ADDENDUM NO. 1

**Administration Building Renovation Re-bid
Compton Community College District**

tBP Project. No. 20987.00

tBP/ARCHITECTURE

1ST FLOOR PLAN
SCALE 1/8" = 1'-0"

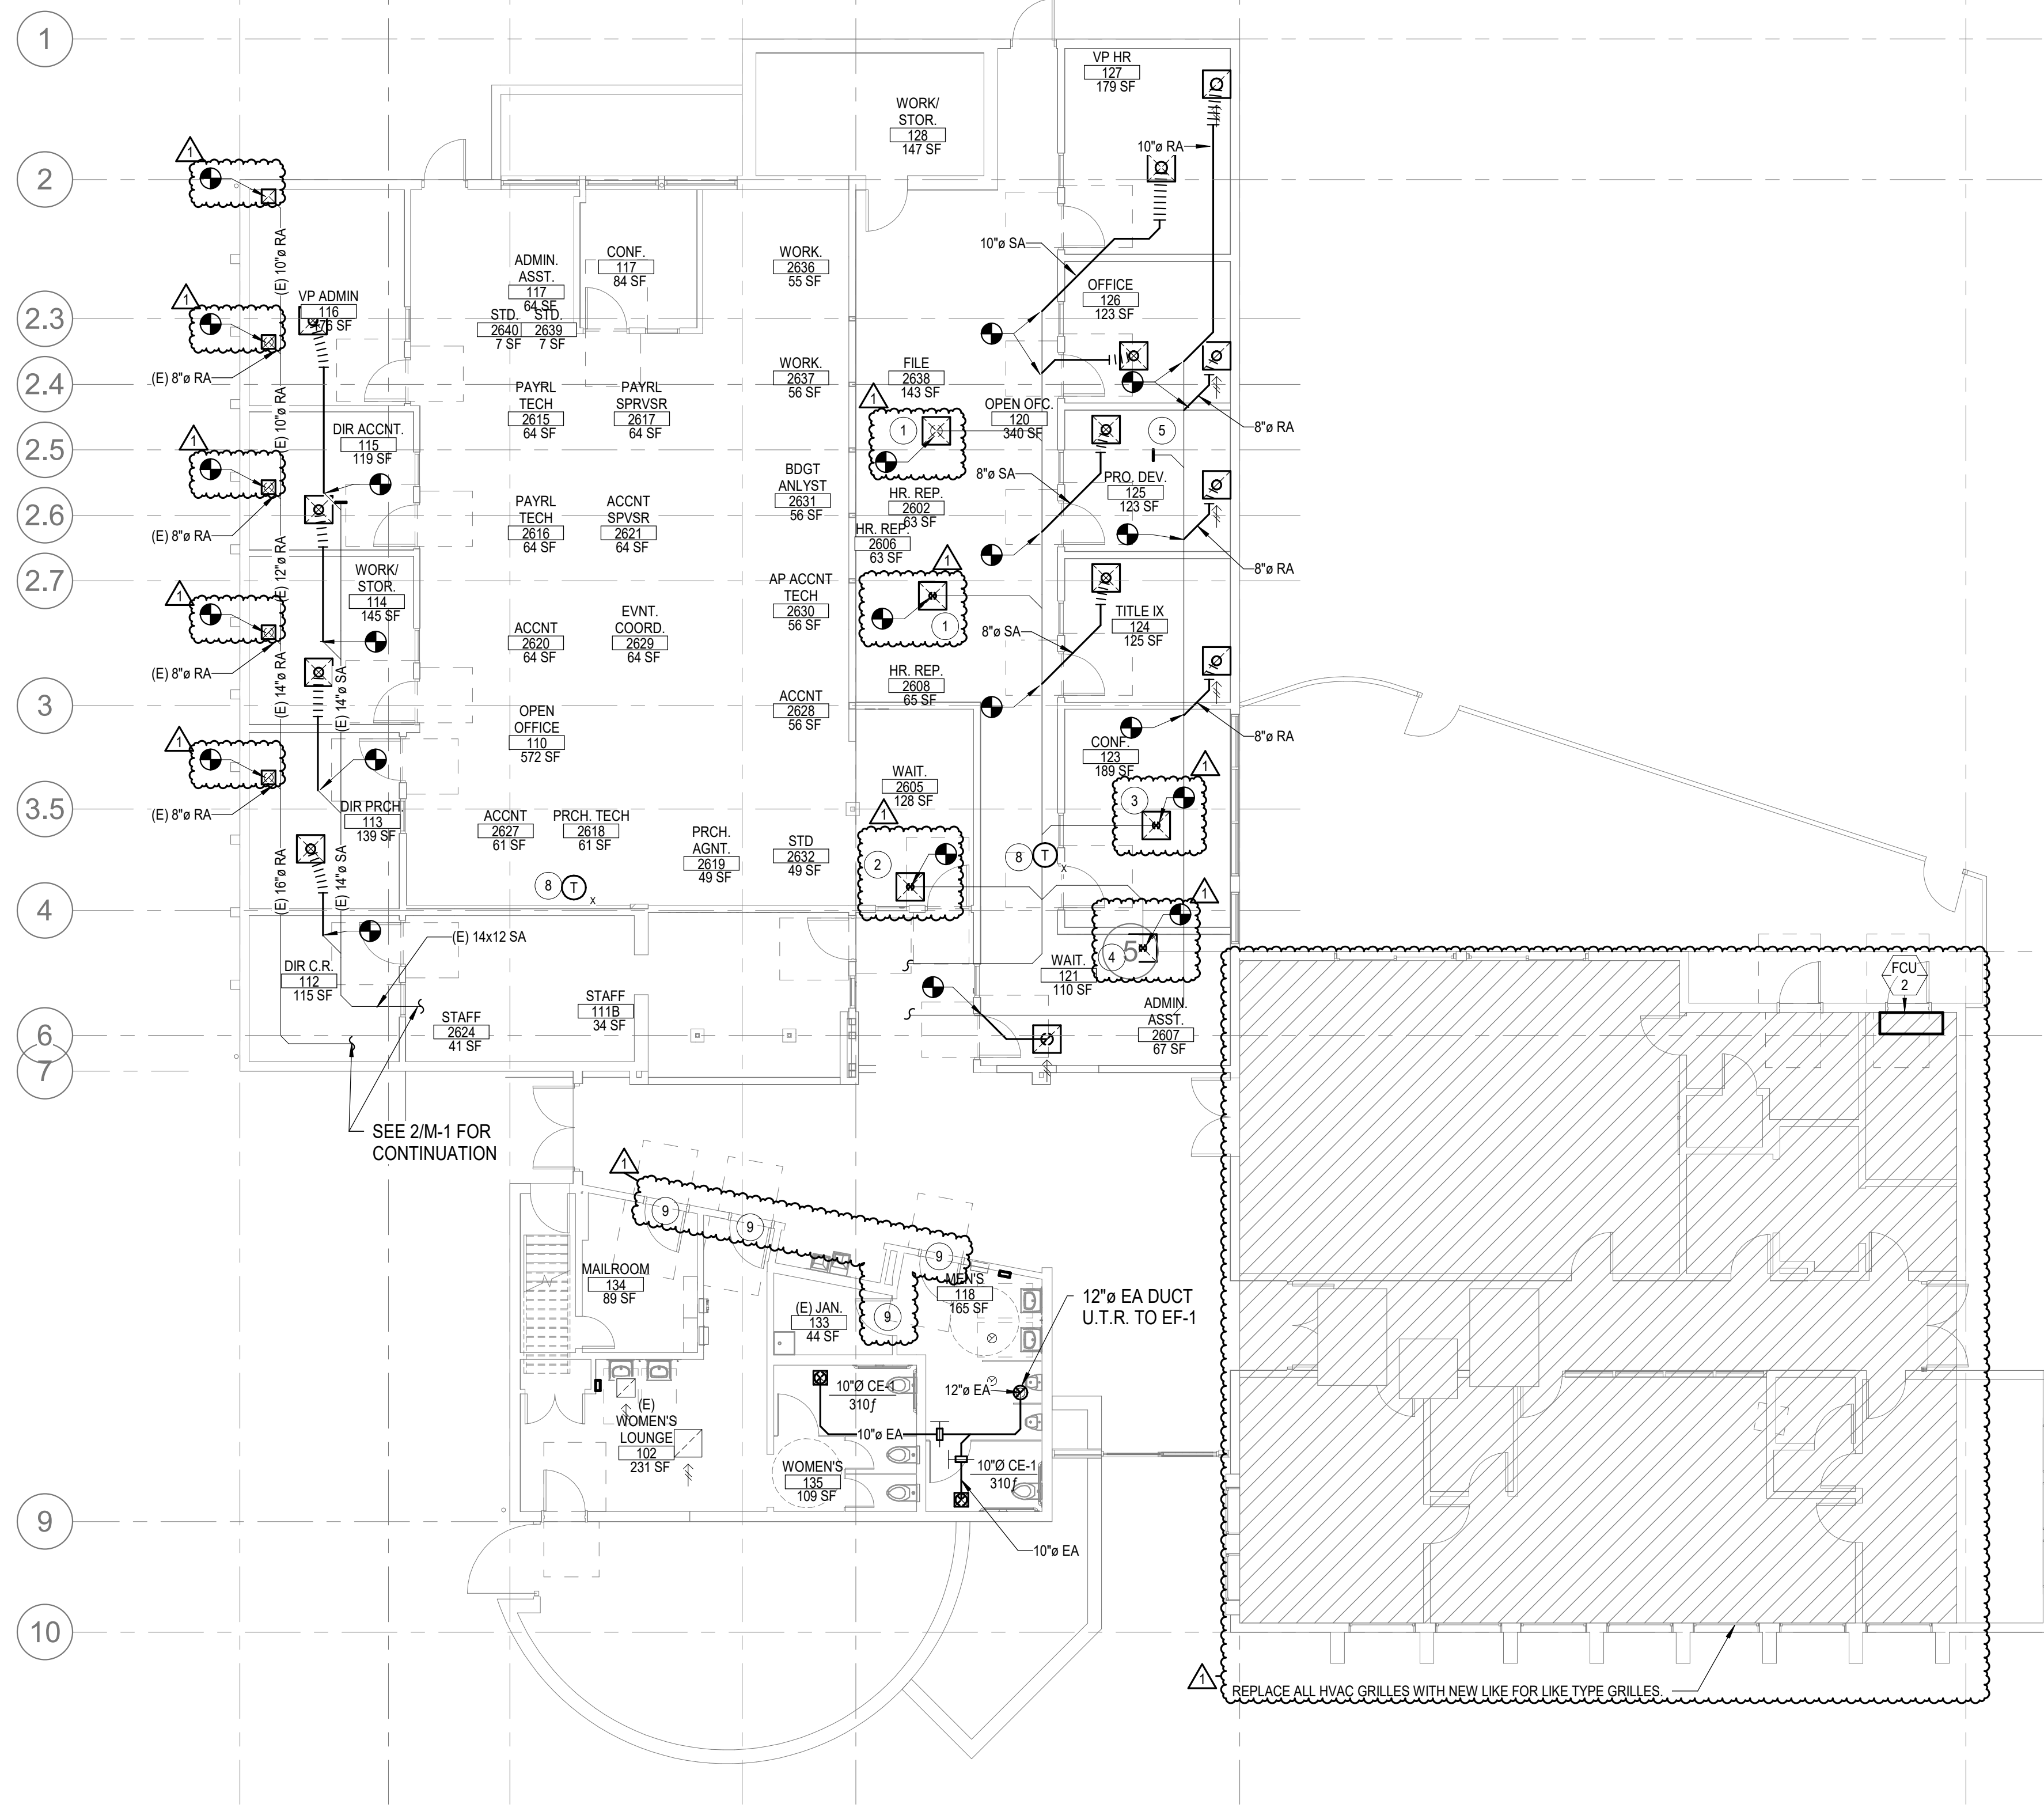
18. **Revised SHEET 9.11 FLOOR FINISH PLAN**
- a. Revised Lobby area floor finish to be LVT instead of Terrazzo.
 - b. Removed Carpet floor Finish and LVT2 to be all replaced by LVT-1.
See attached revised Full size sheet identifying revisions included as part of this addendum.

drawing no.:
M-1
drawing of

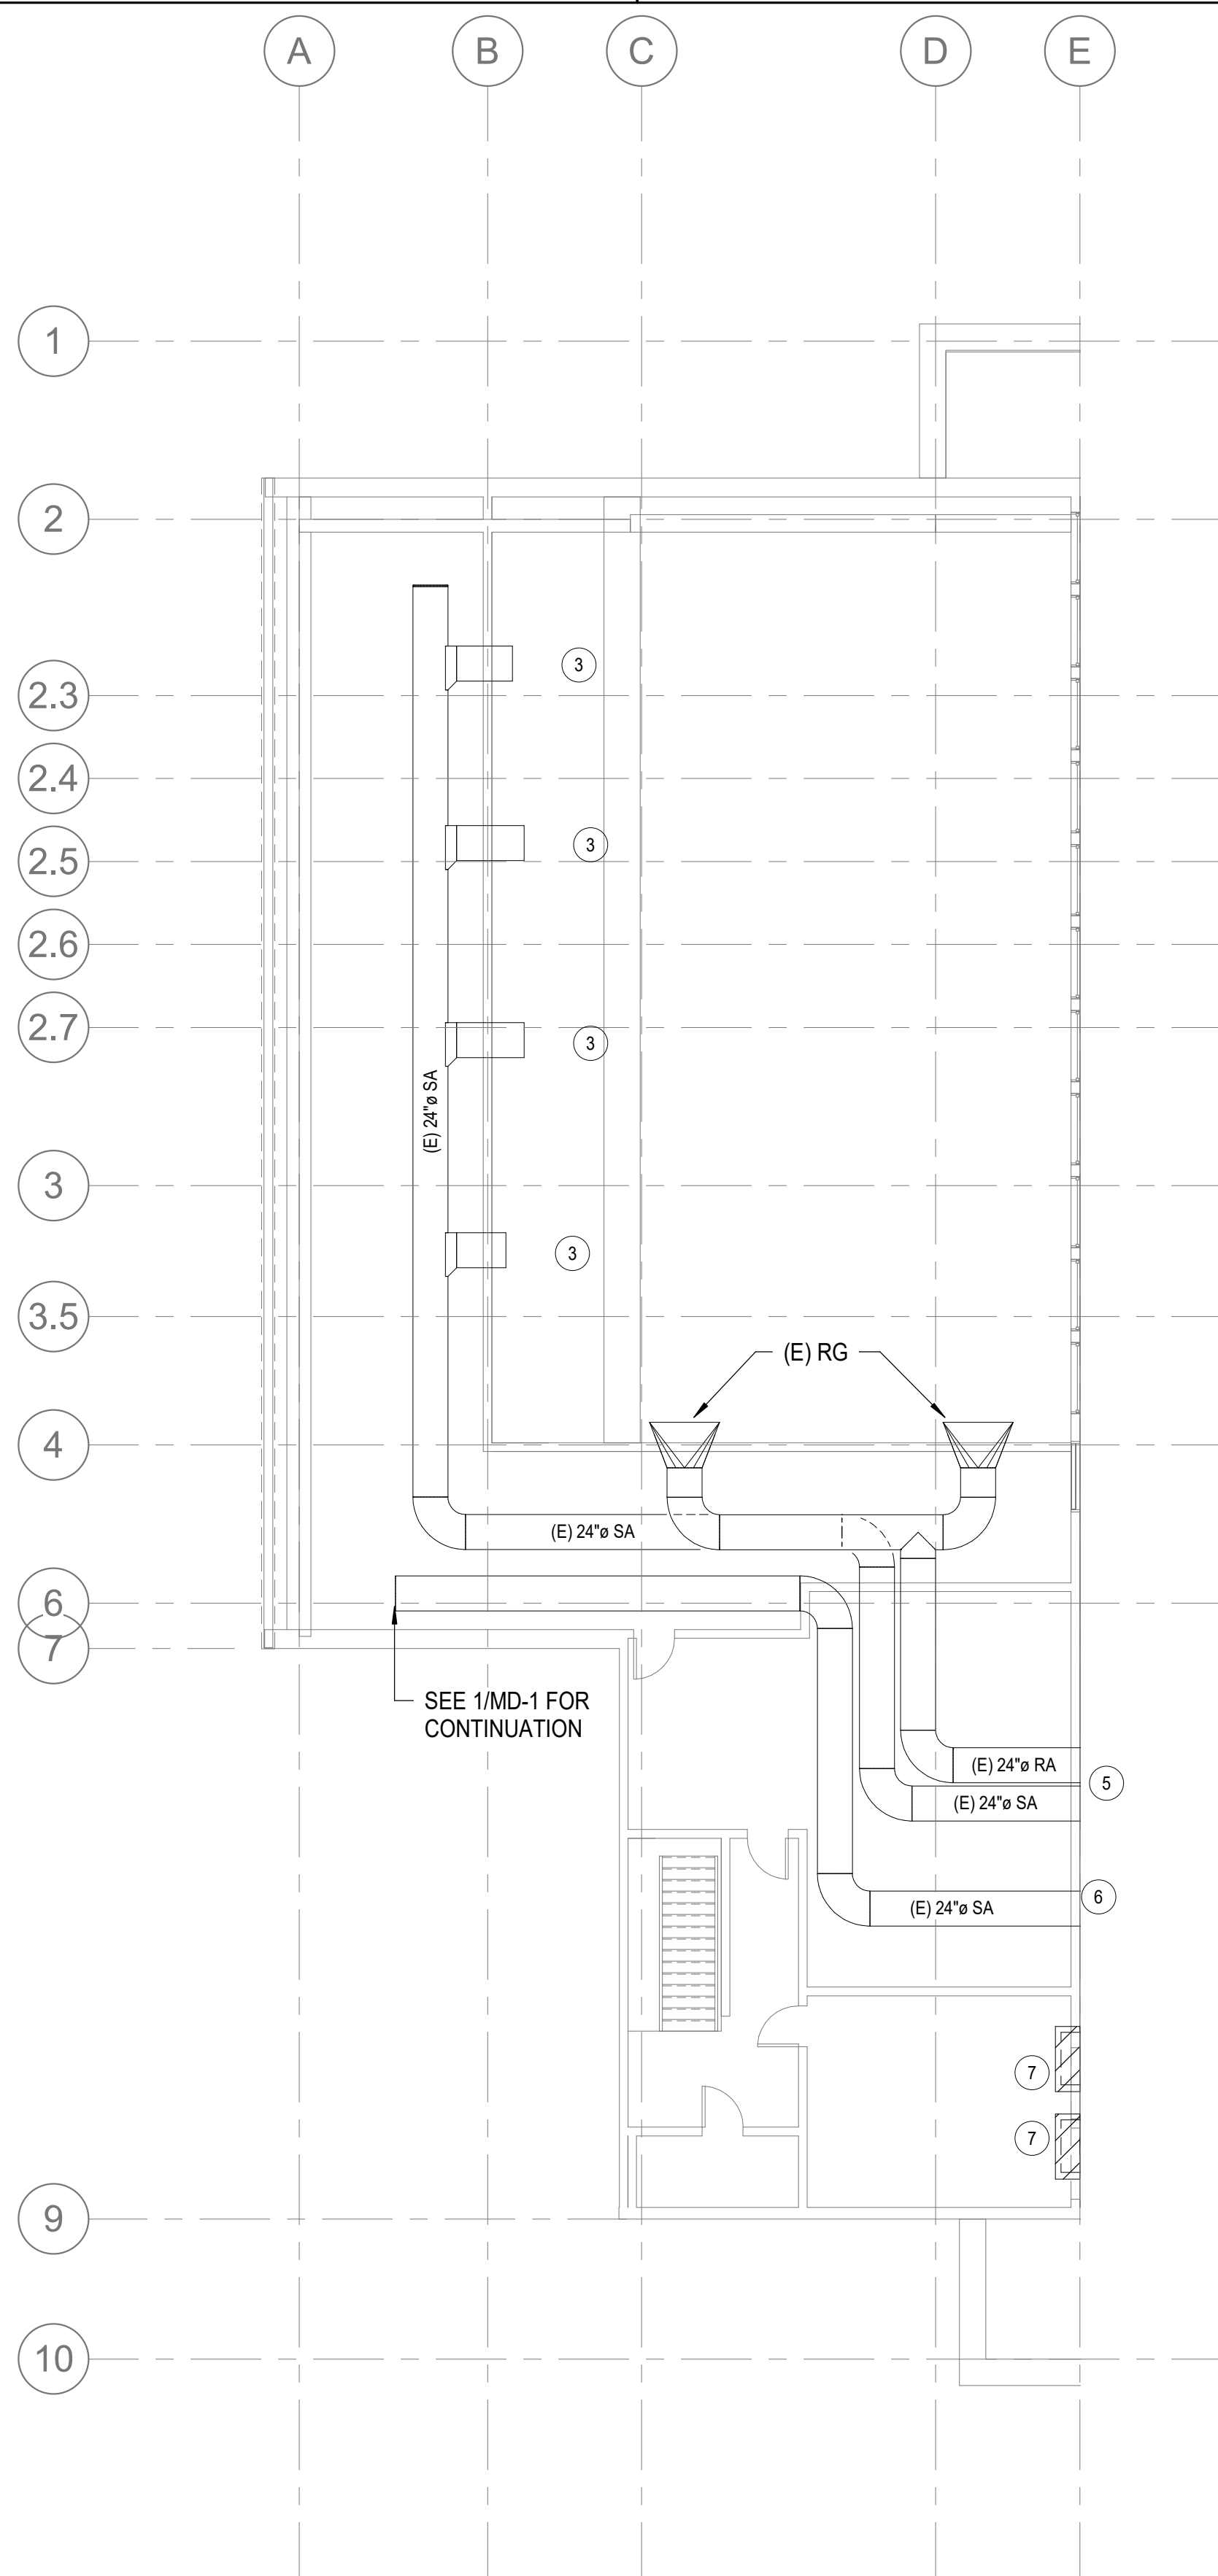
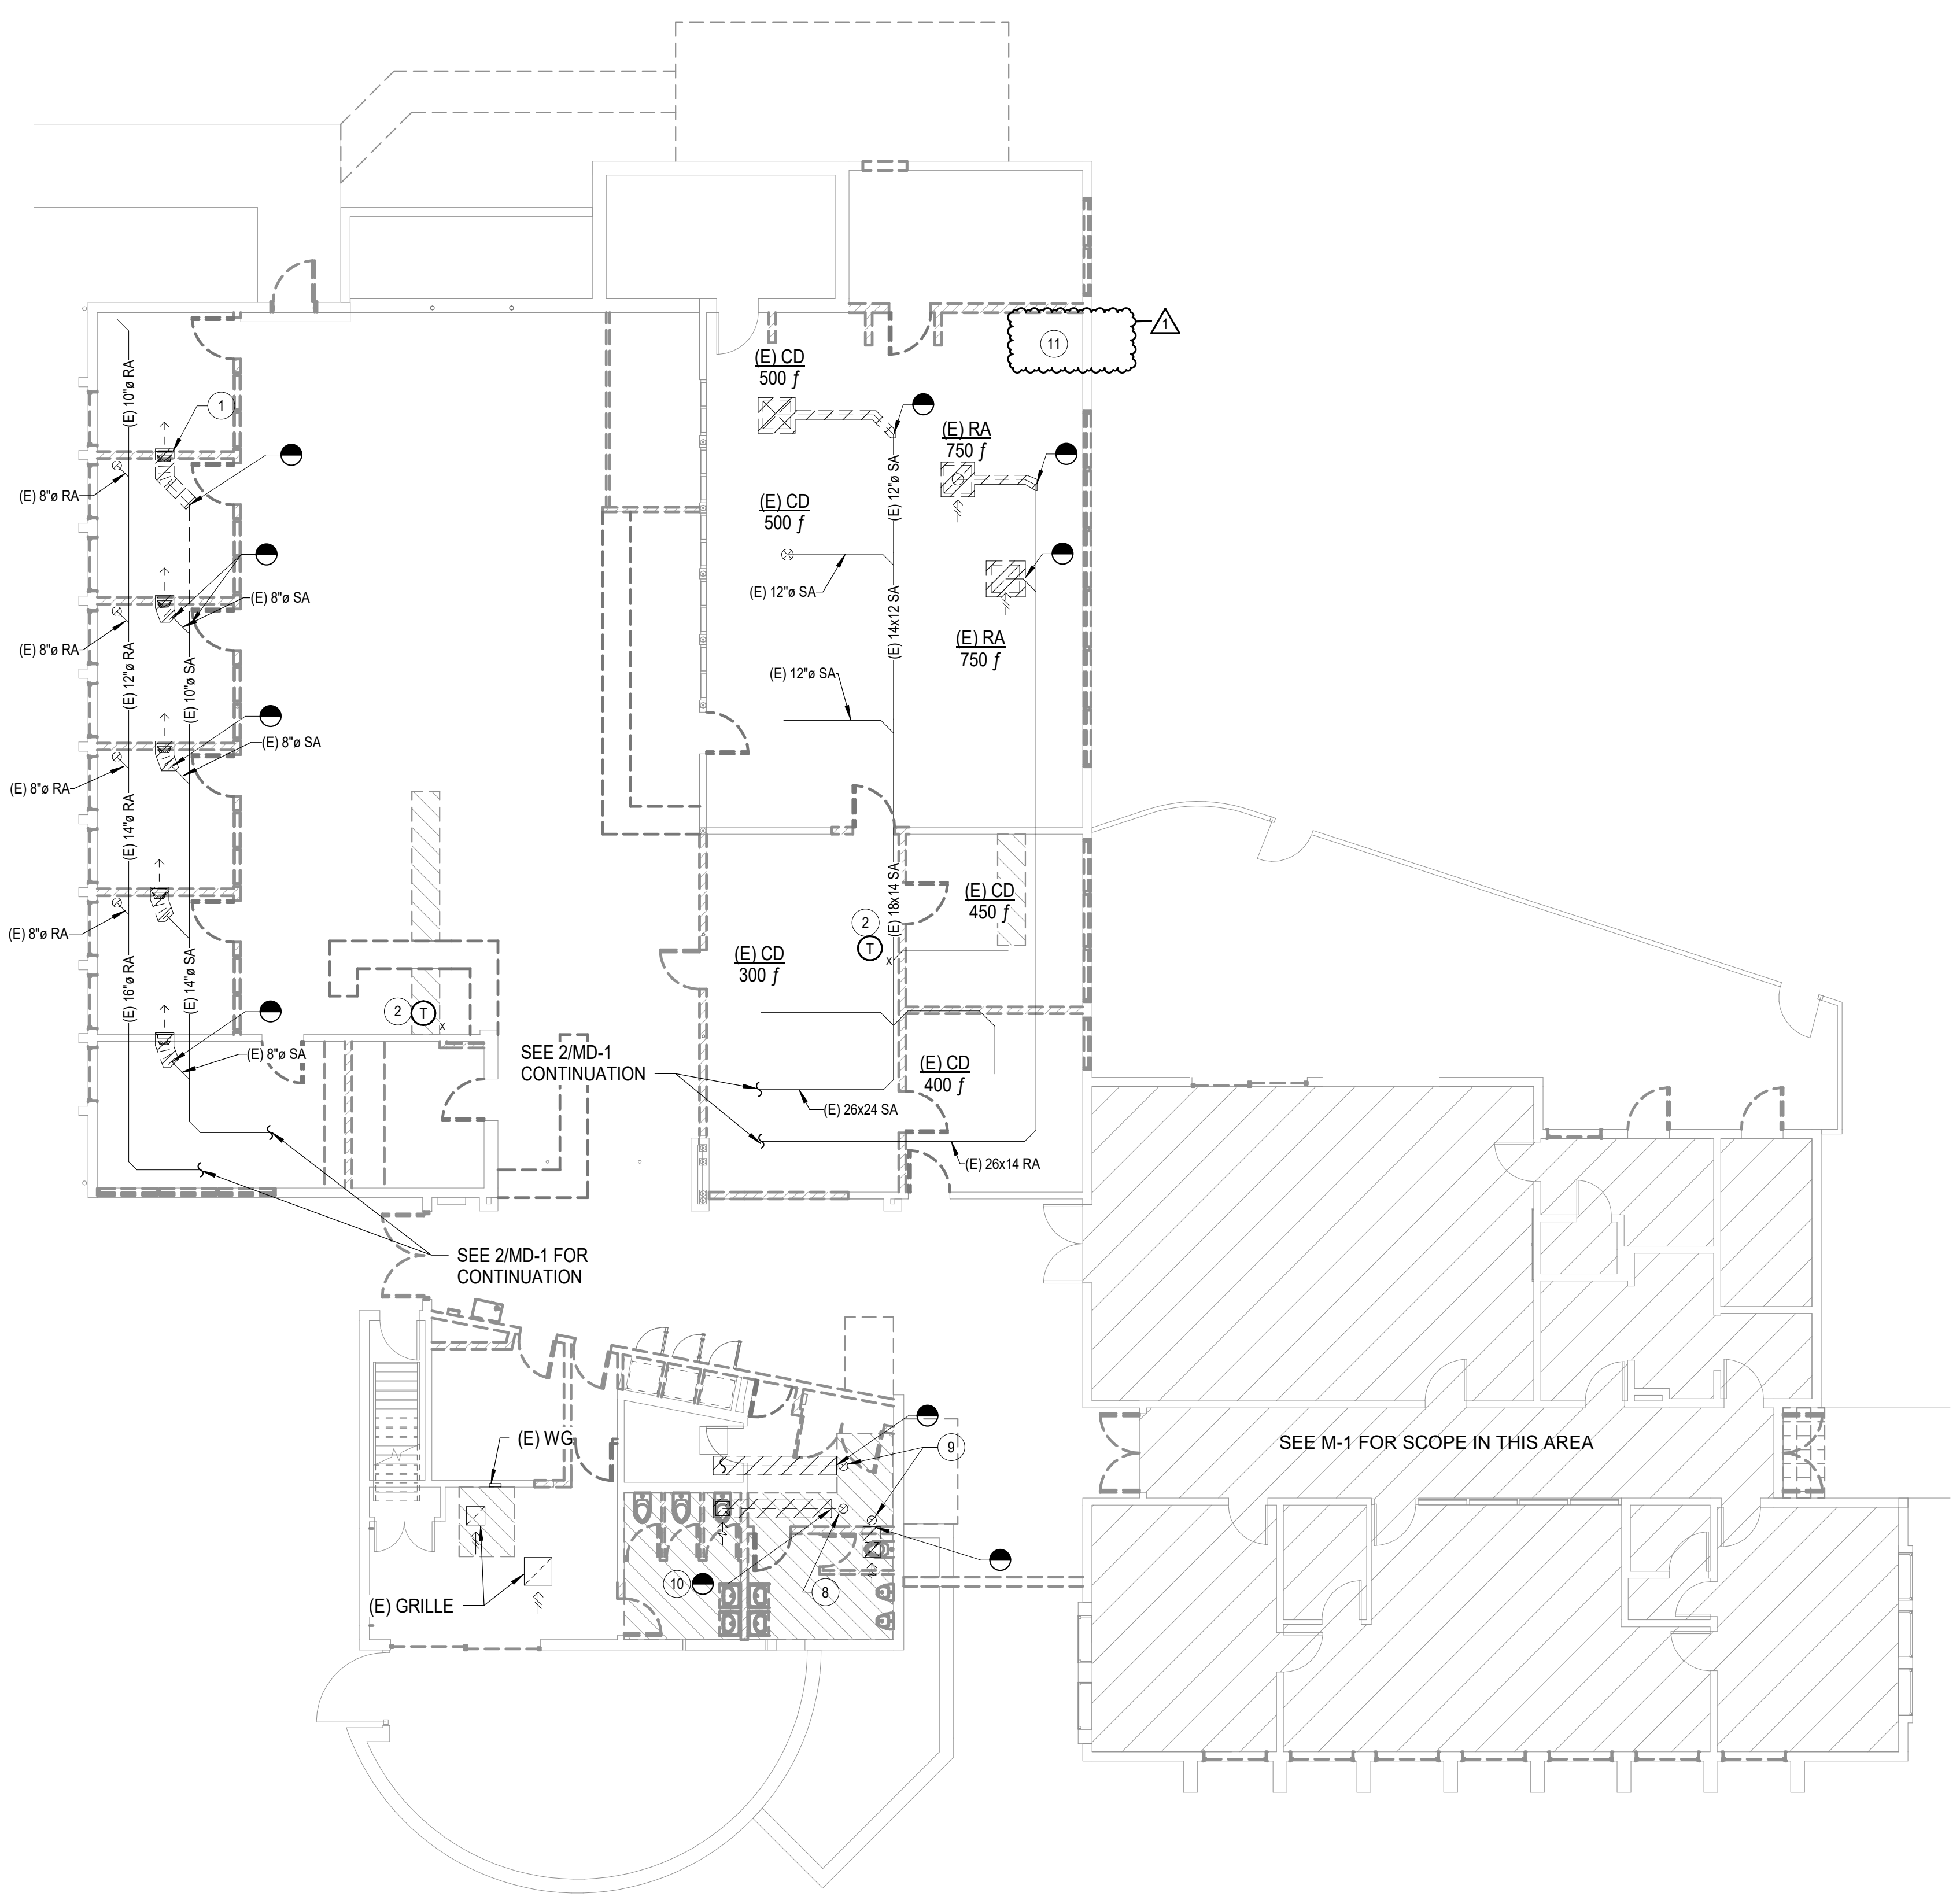
- 19 **Revised Sheet M-1 MECHANICAL REMODEL FLOOR PLAN**
- c. Added notes for door undercuts.
 - d. Updated note to call for all new HVAC grilles for the entire project.
See attached revised Full size sheet identifying revisions included as part of this addendum.
